Central Kitsap Fire and Rescue
Station 45

Bid No. 2022-STA45BUILD-50-01

ADDENDUM # 1
April 20, 2022

DEMOLITION &
T.E.S.C. PLAN

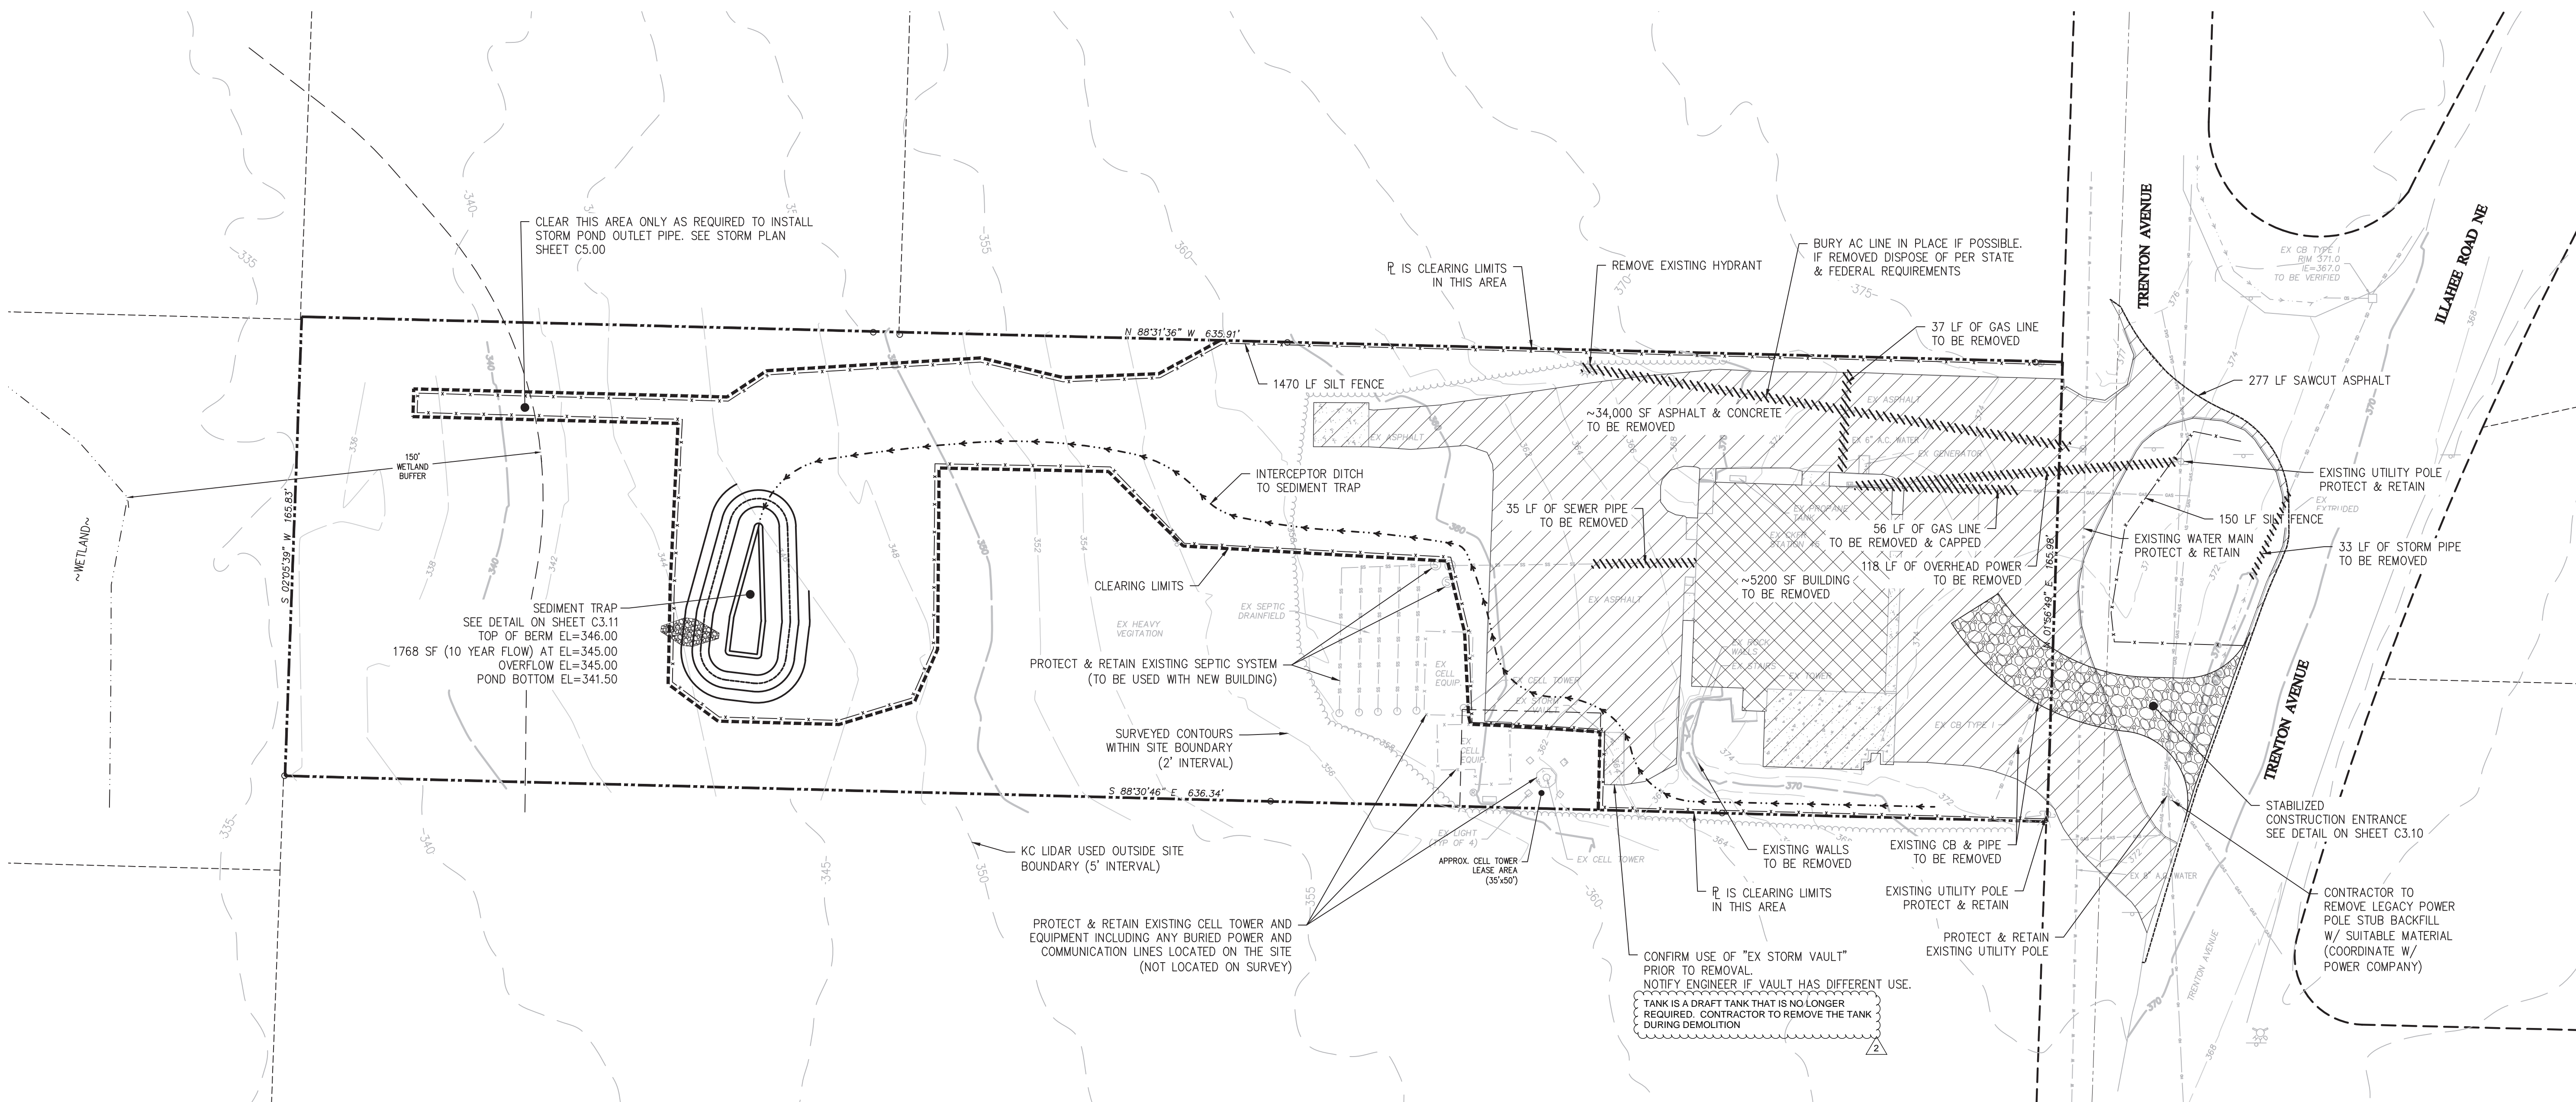
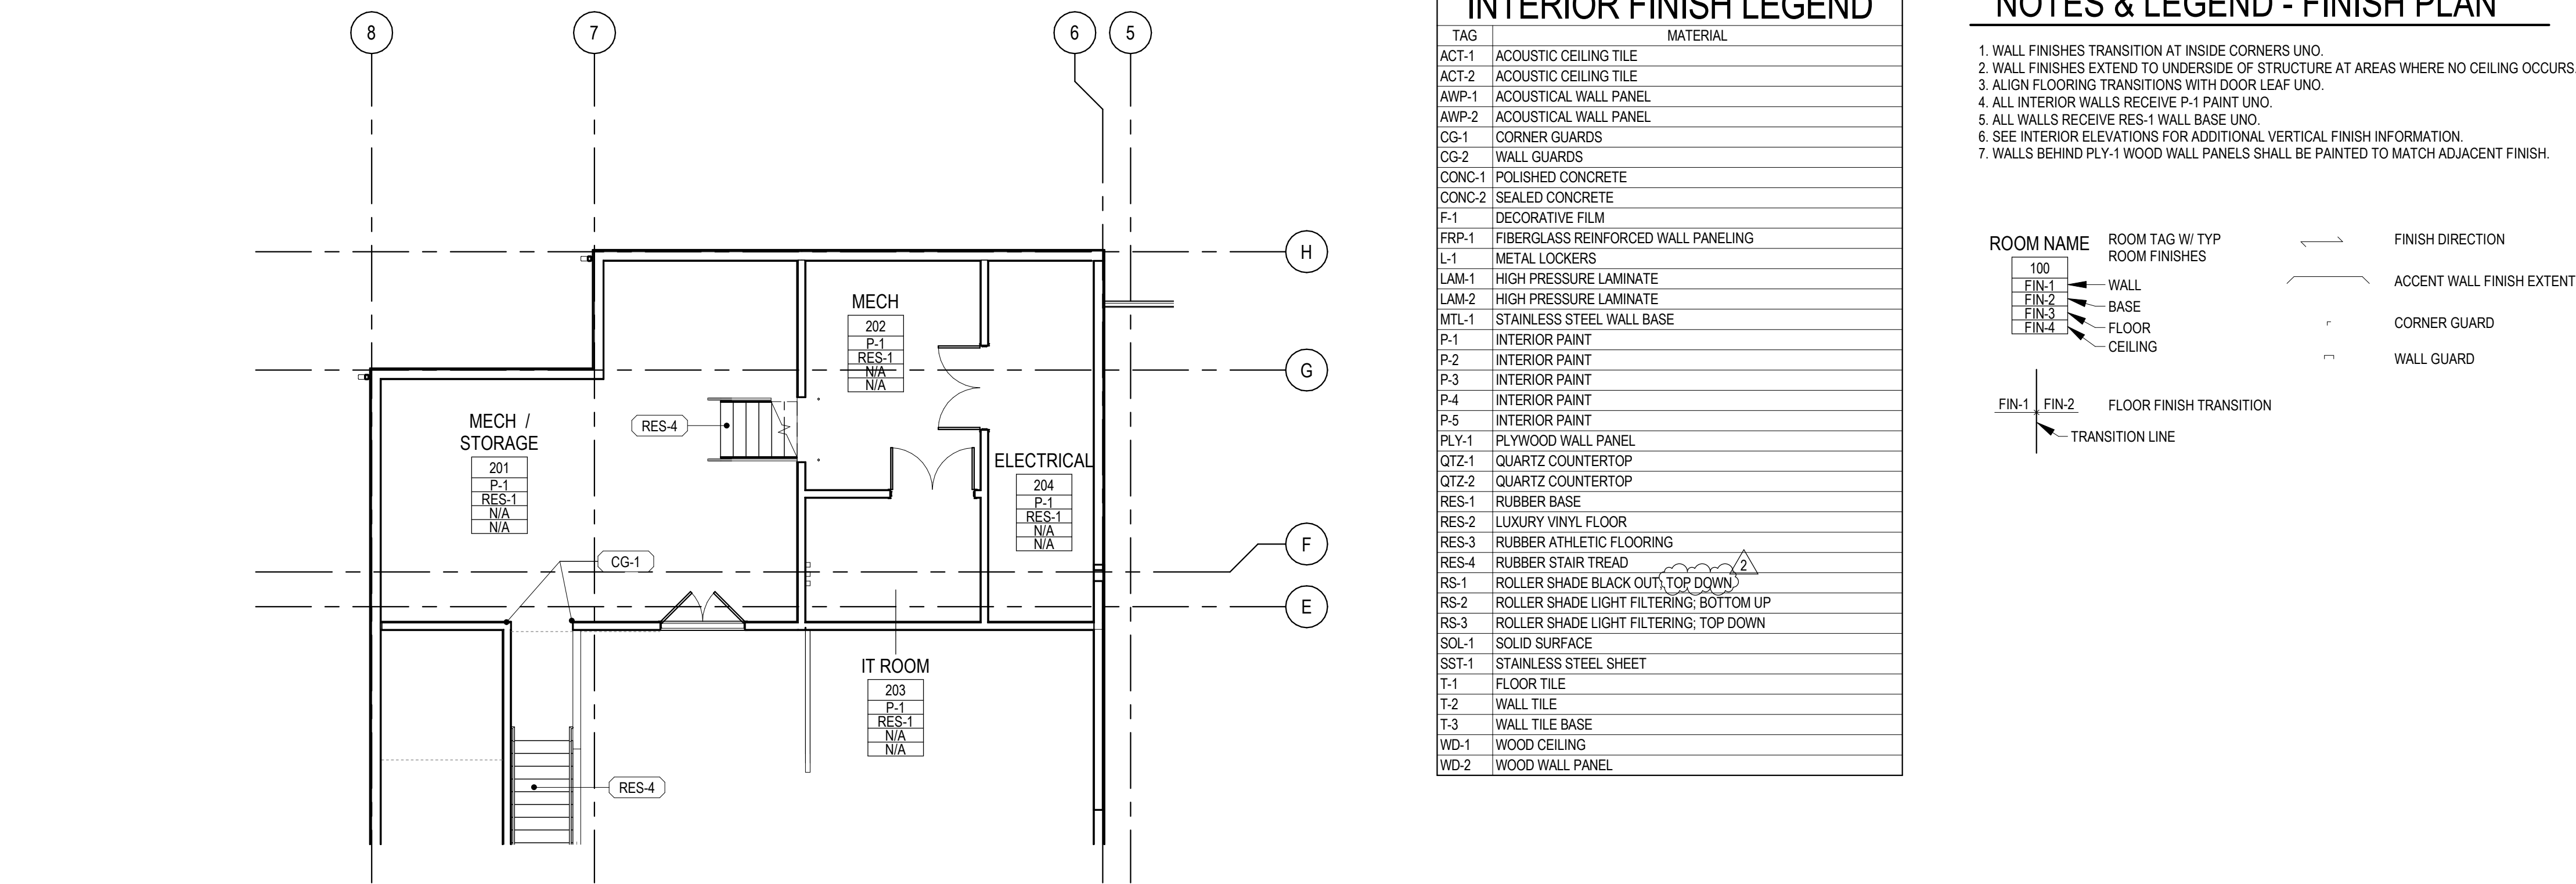
- ITEM 1. DRAWING C3.00
 - a. REPLACE SHEET: Note addressing the "ex storm vault" has been clarified. Draft tank to be removed by contractor.

2 FINISH PLAN - LEVEL 2

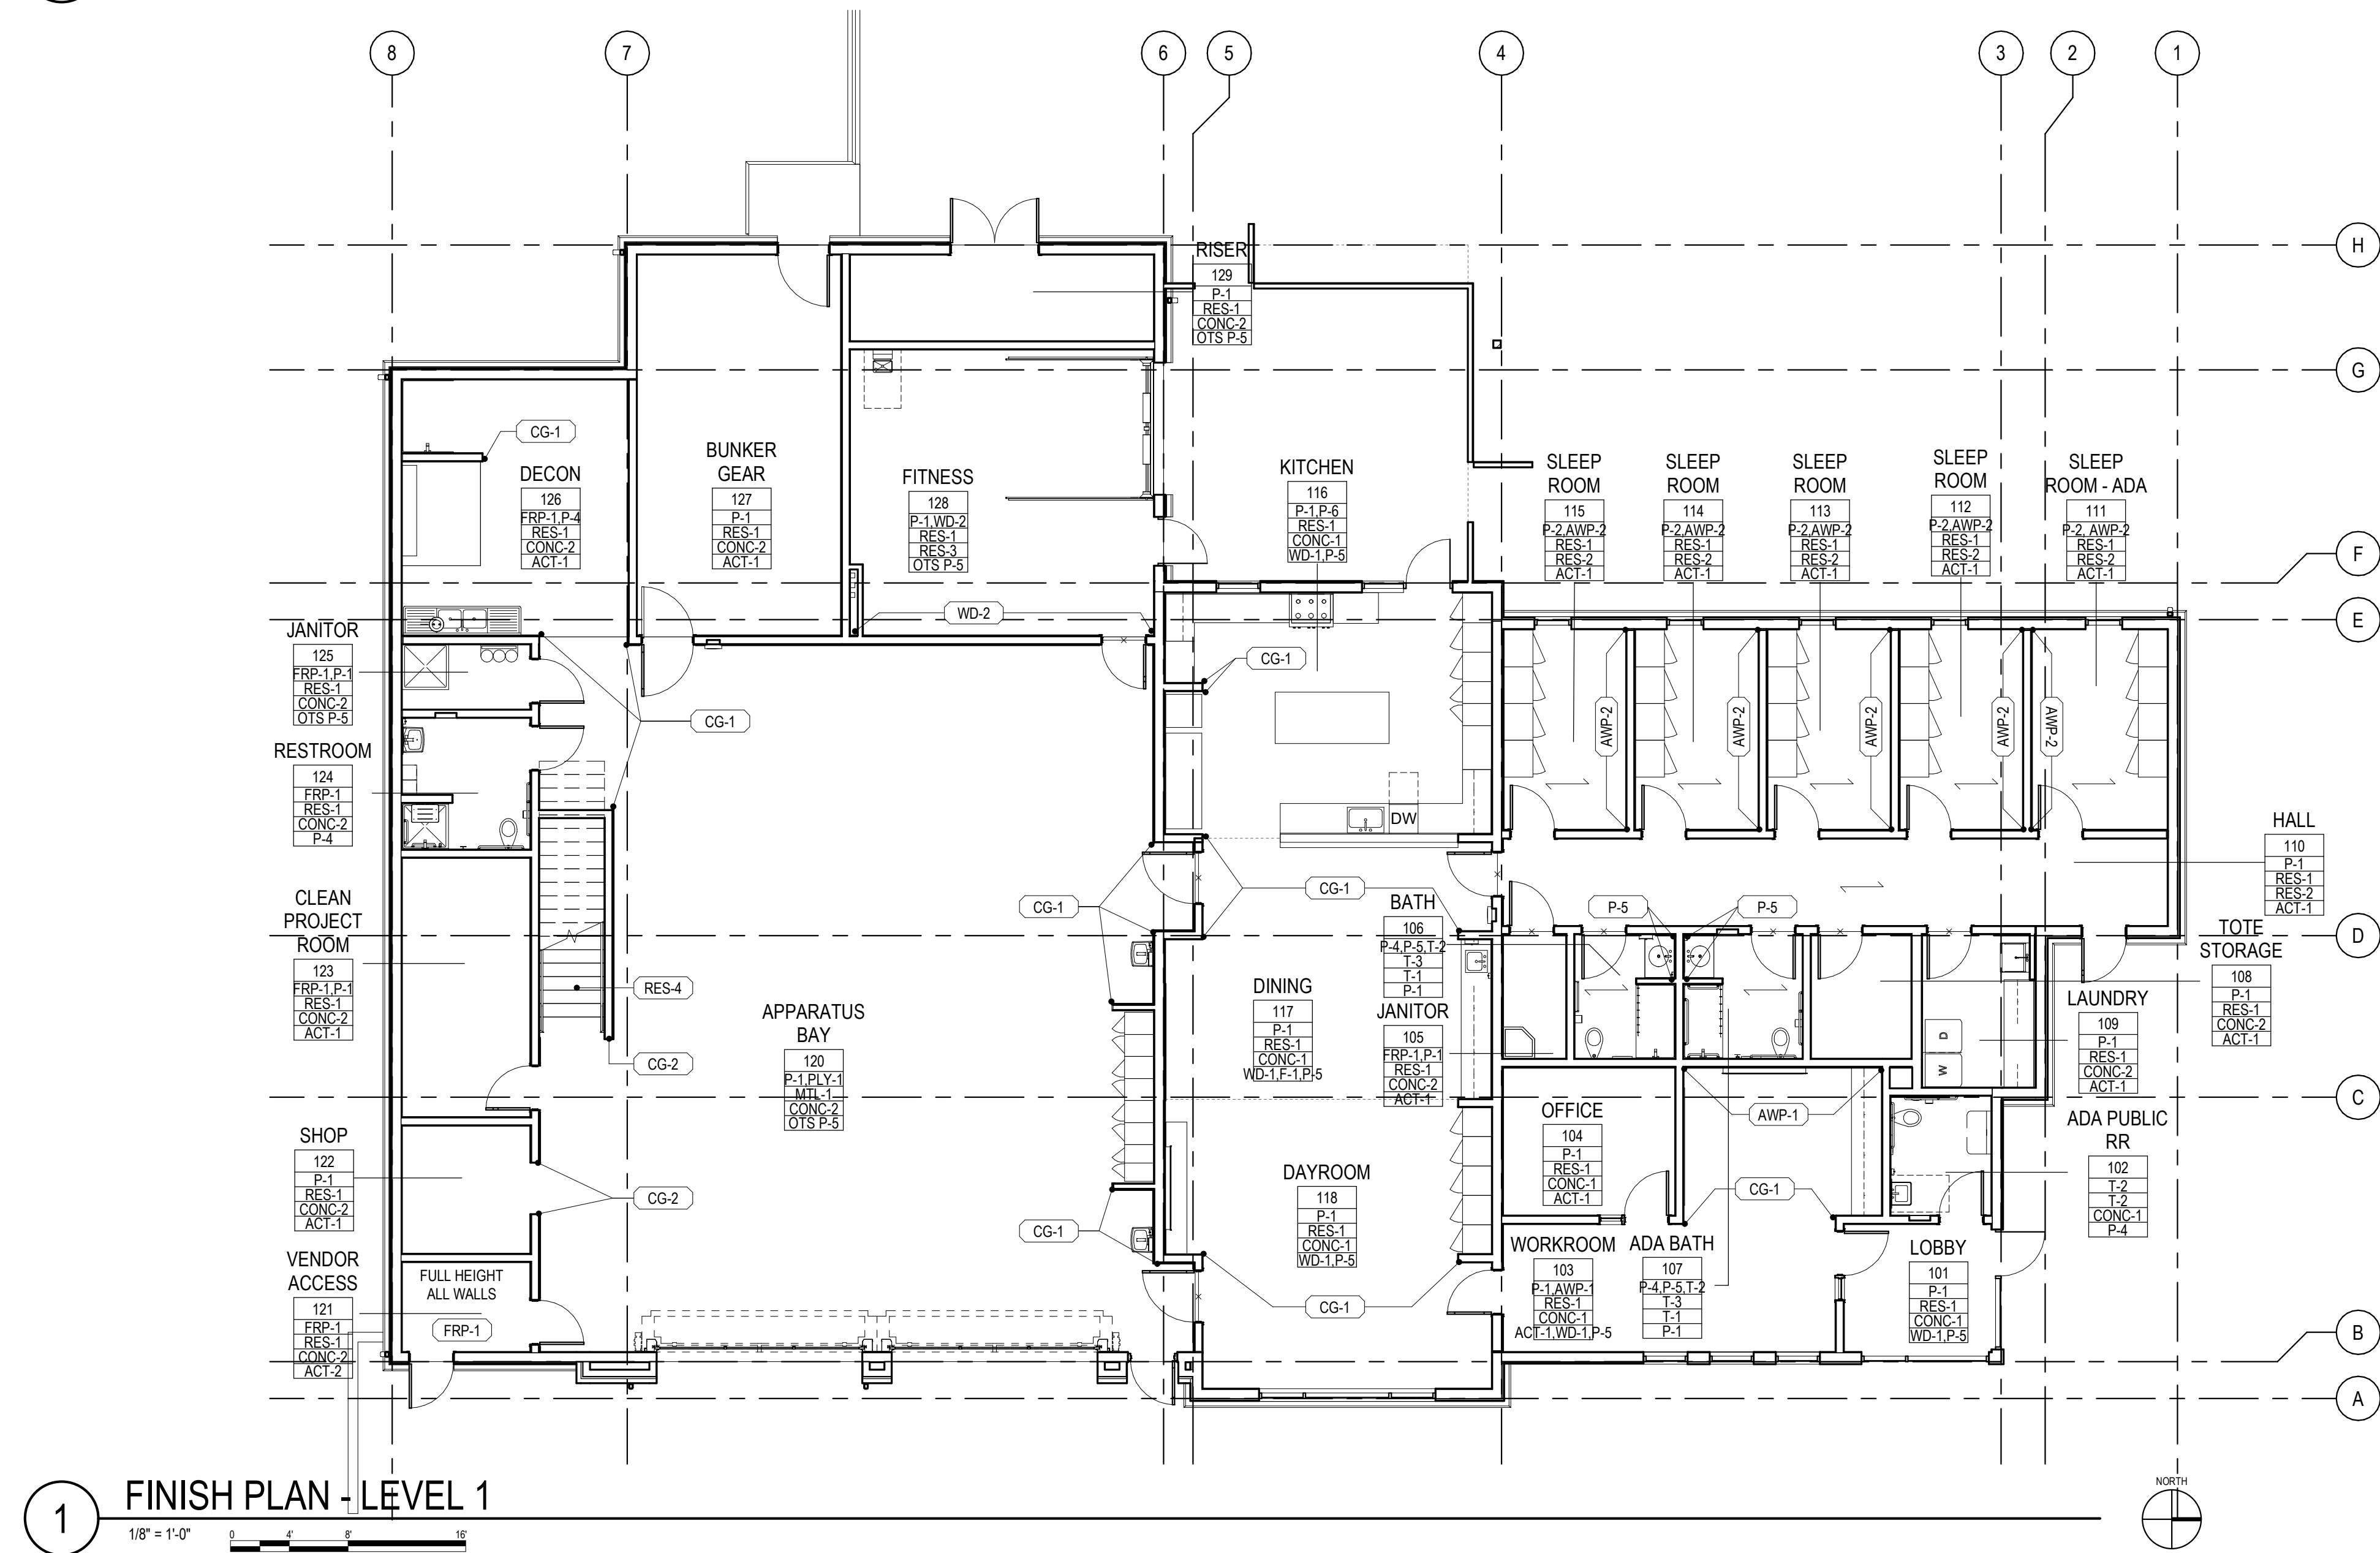
- ITEM 1. DRAWING A23.01
 - a. REPLACE SHEET: Revised RS-1 in the finish legend to read Roller Shade Black Out, Top Down
- ITEM 2. DRAWING A26.01
 - a. REPLACE SHEET: Revised Enlarged Plan 5 to show a 36" x 36" clear opening for the shower.
- ITEM 3. DRAWING A28.01
 - a. REPLACE SHEET: Revised roller shade at east end of Dayroom 118 to an RS-3.
